Service Bulletin

Subject: Engine May Shut Off After Wide Open throttle Maneuvers SES Lamp Setting P0121 P02101 And P2119

Brand:	Model:	Model Year:		VIN:		Engine:	Transmission:
		from	to	from	to		
Cadillac	CTS-V	2016	2017	SOP	END	6.2 LT4	N/A

- **1.** This is the incorrect air filter with no glue lines
- 2. This is the correct air filter with glue lines

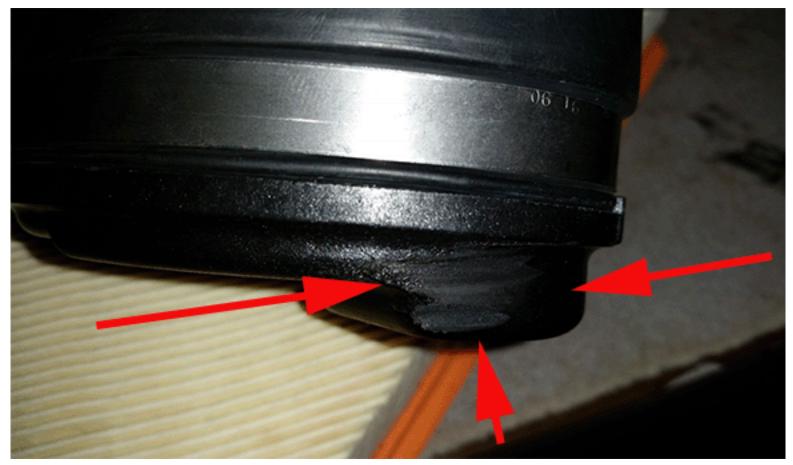
Inspect the air filter for damage from being collapsed shut as shown below by filter #1.

Replace the air filter if it is incorrect

If this is encountered the air duct should be replaced with the air filter.

When the air duct collapses it may come in contact with the supercharger idler pulley Do not replace ECM, Throttle Body.
